Docket Item #6
BAR CASE #2004-0144

BAR Meeting
August 25, 2004

ISSUE: Addition
APPLICANT: Vanna So
LOCATION: 1204 Princess Street
ZONE: RB/Residential

Figure 1 Front Elevation (Revised Plans)

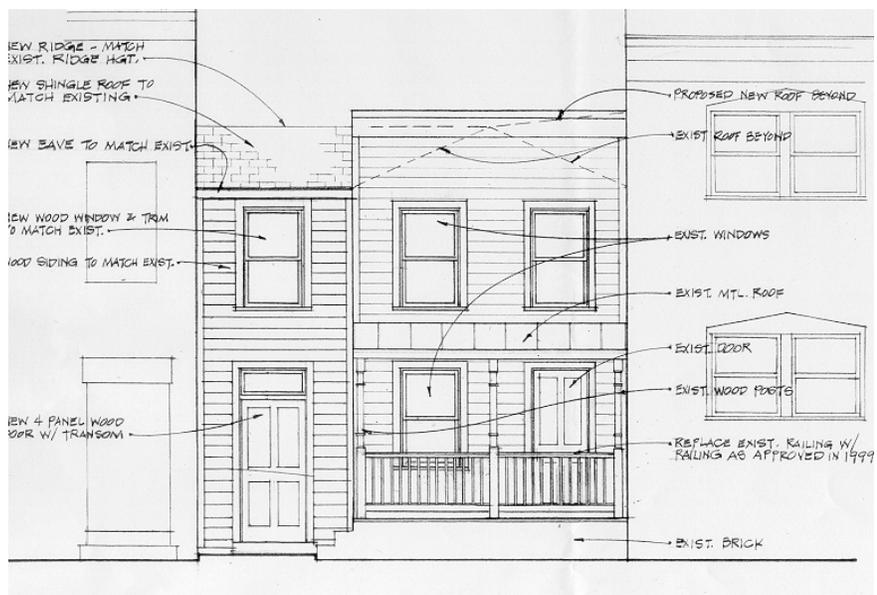
The front (north) elevation of the addition will be approximately 7.5' wide, filling in the unbuilt area to the east of the house. It will be set back from the front wall of the existing house by approximately 8'. The porch and parapet shown in the previous design for this elevation have been eliminated. The resulting simplified north elevation consists of a four panel wood door with full light ransom on the first story and a one-over-one window above in the second story. Rather than the false front of the previous design, a simple fascia board marks the eave line and the edge of the gable roof.
